ADDENDUM NO. 2

IRONDALE FIRE STATION No. 3

Project Name: Irondale Fire Station no. 3 **Project No:** CWA Project No. 2023-01

SHEET TITLE: SITE UTILITY PLAN PROJECT NUMBER: CWA No. 2023-01

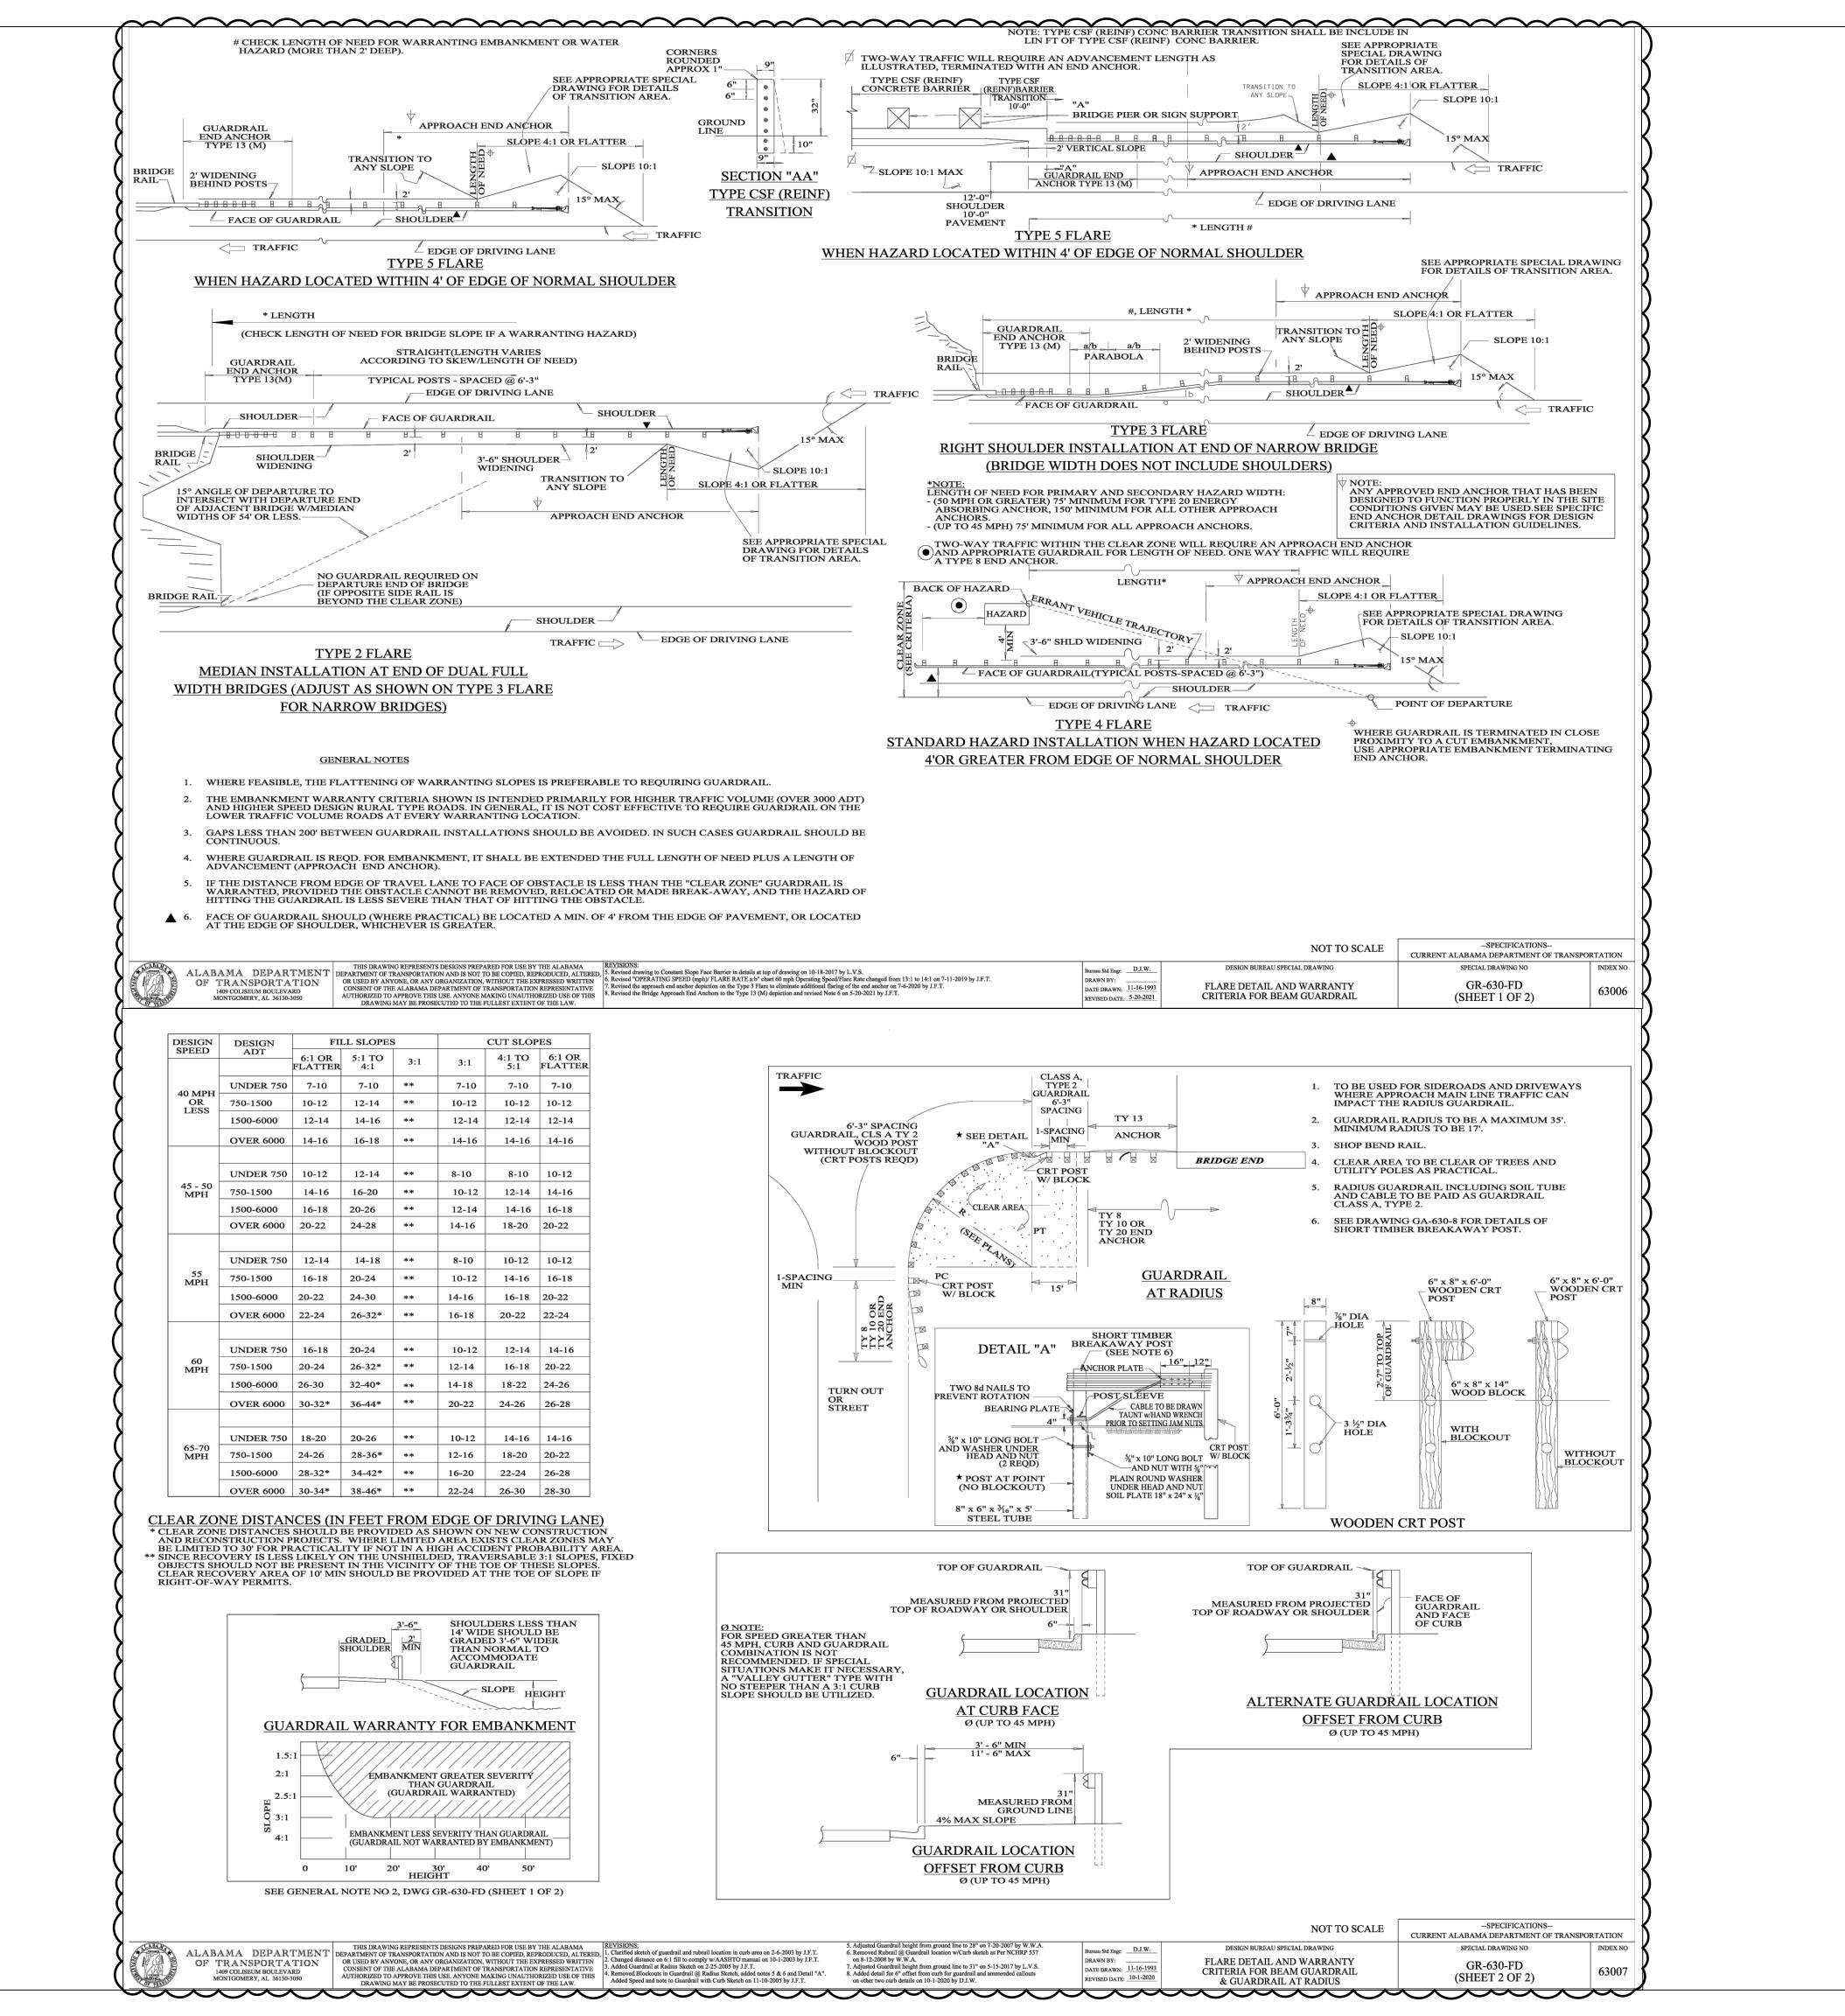
- 2. C3.0 Site Utility Plan:
 - a. Removed separate irrigation water tap and meter. Irrigation service will tee from the domestic water line.
 - b. Added notes regarding project fee coordination
- 3. C5.4 Details: Added details for guardrail replacement
- 4. L5 Landscape Details: Added dimensions to plaza and paver layout
- 5. A2.21 ENLARGED PLAN BLOCK B (DORM):
 - a. Deleted details 12/A11.01, 2/A2.21, 3/A2.21
 - b. Added elevations 3/A11.05, 4/A11.05, 1/A11.03, 2/A11.03, 3/A11.03, 4/A11.03, 5/A11.03, 6/A11.03
- 6. <u>A3.01 Roof Plan</u>: Change Roof Plan Keynote no. 1 to read "R-25 rigid insulation" instead of 3"
- A3.02 Roof Details: Detail 6, change "ROOF DECK TYP" to "OPTIONAL ROOF DECK IF REQD BY MANUF."

S4.6

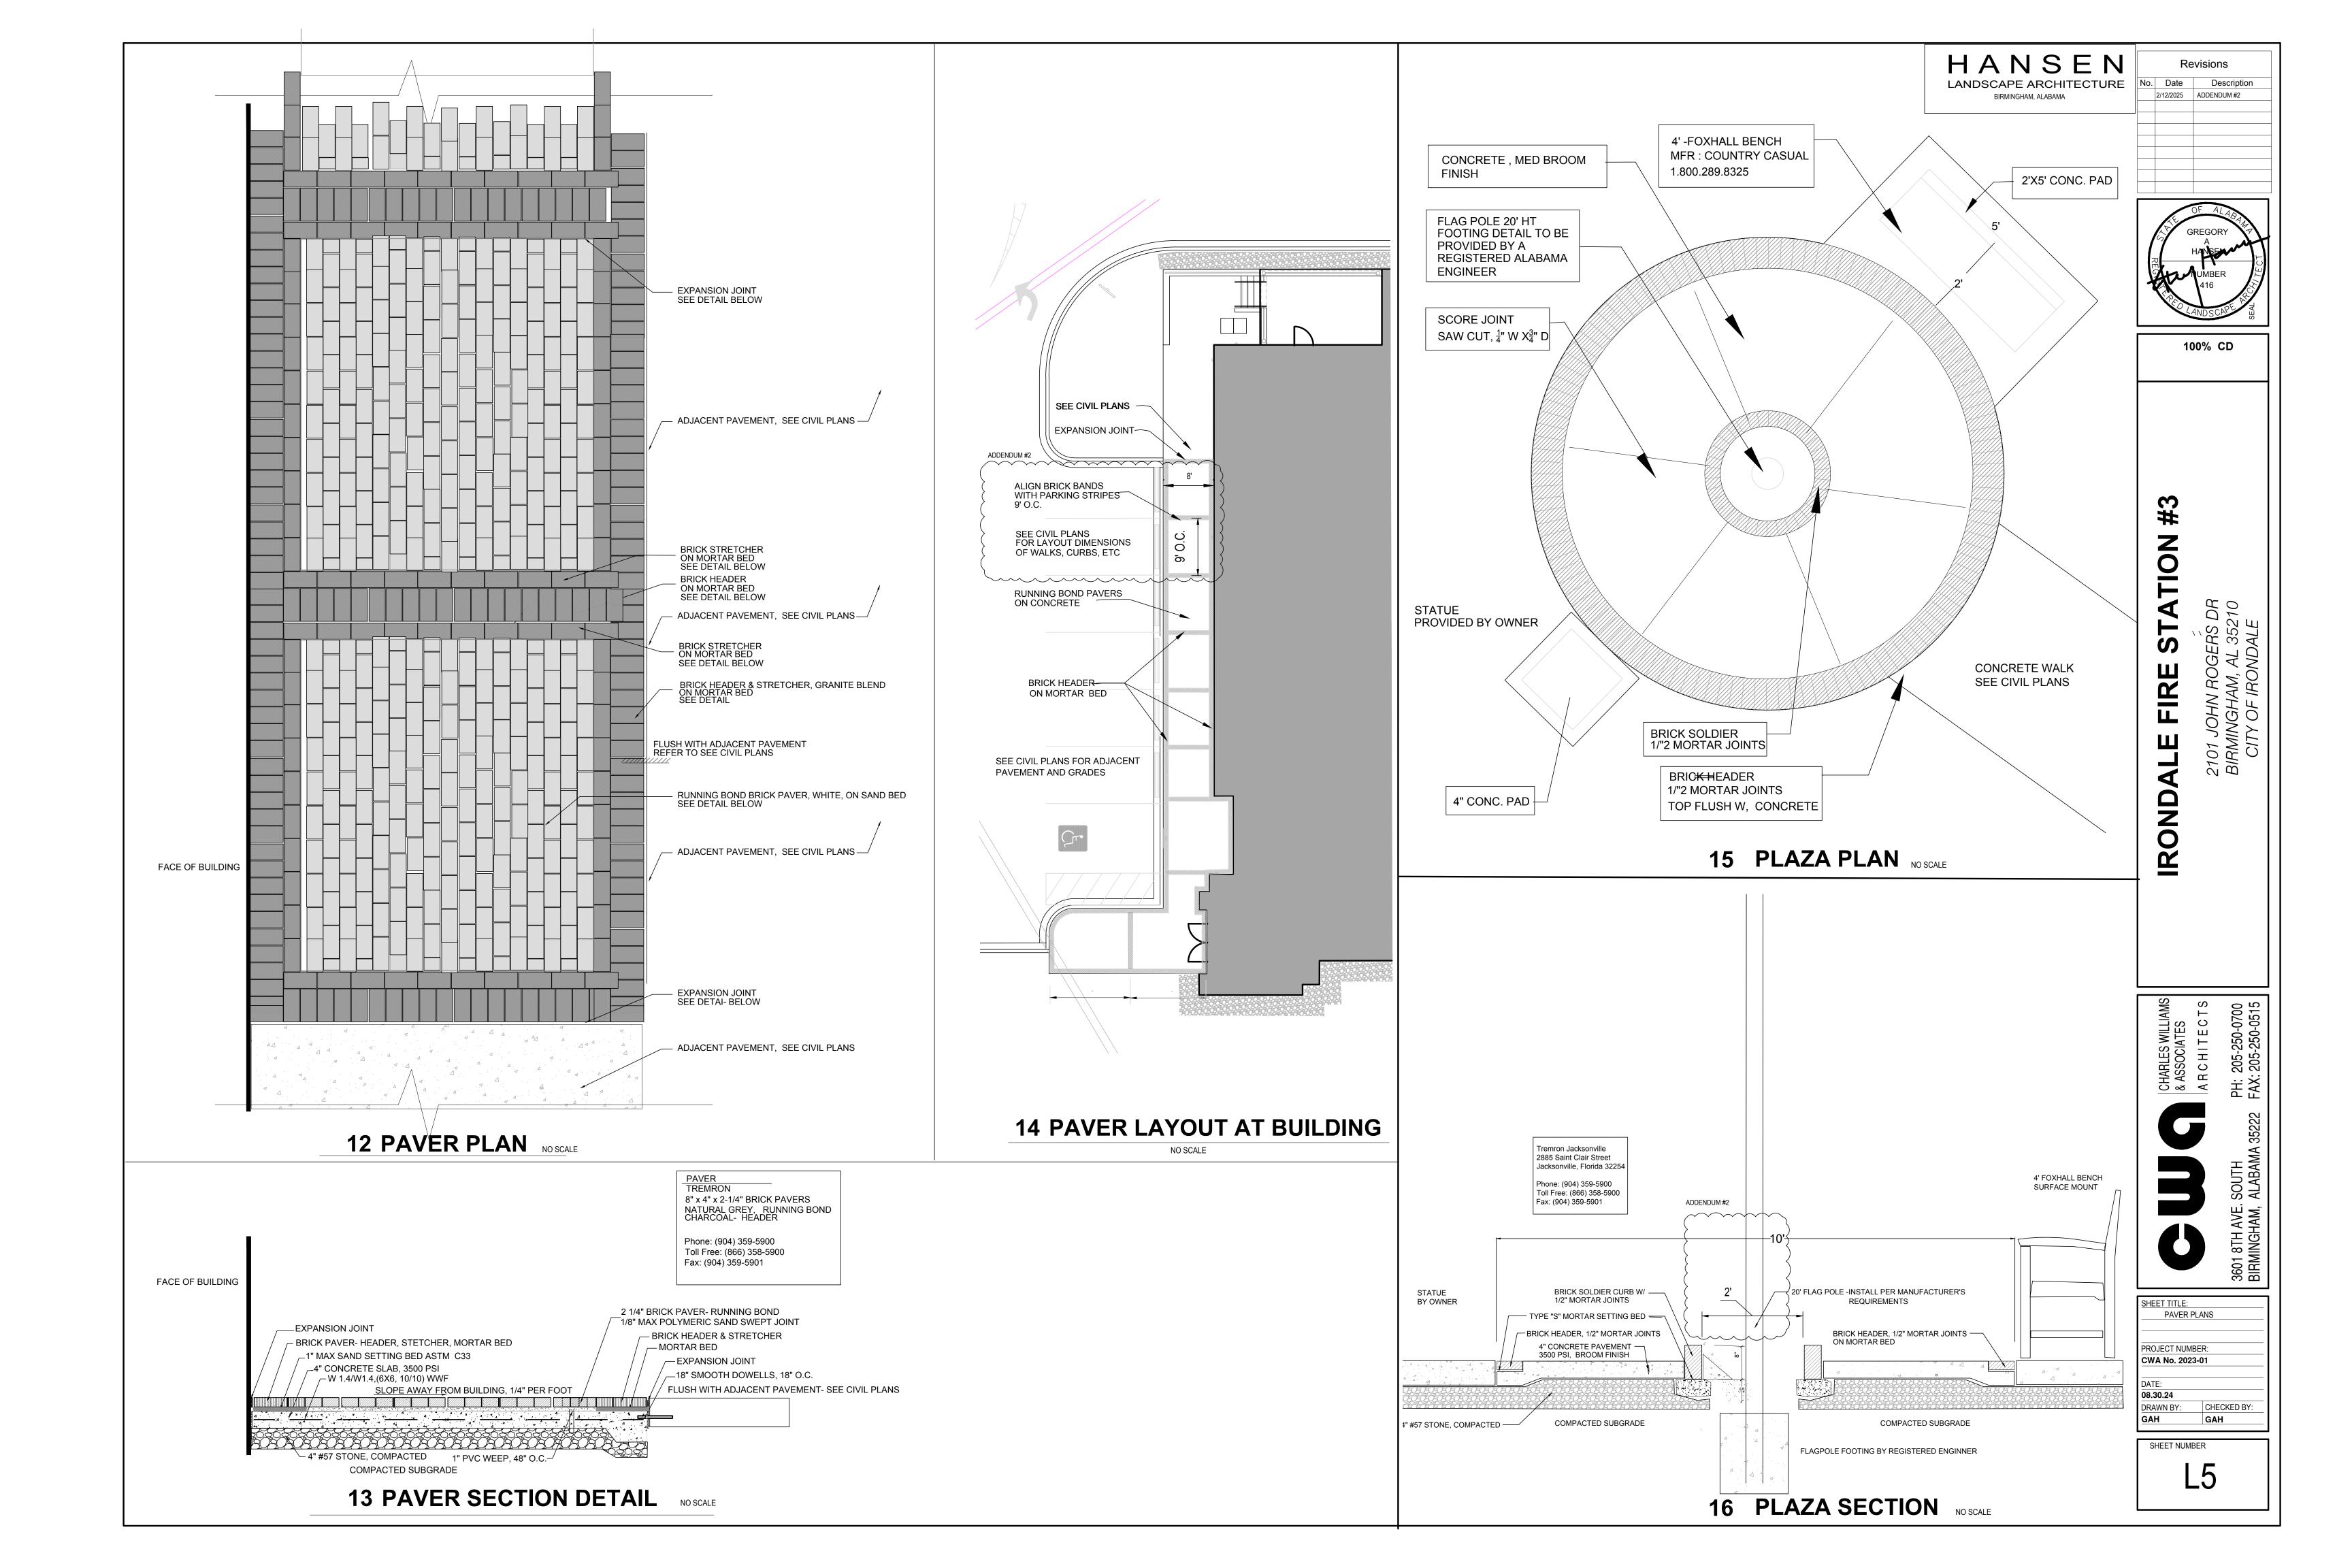
- 8. A4.10 Finish Schedule and Legend: Added finishes SST-1 and PLAM-3
- 9. <u>A11.03 Interior Elevations</u>: Added Kitchen elevations
- 10. <u>S4.6 Sections and Details</u>: lowered the column base plates 0'-6" at Front Entry.
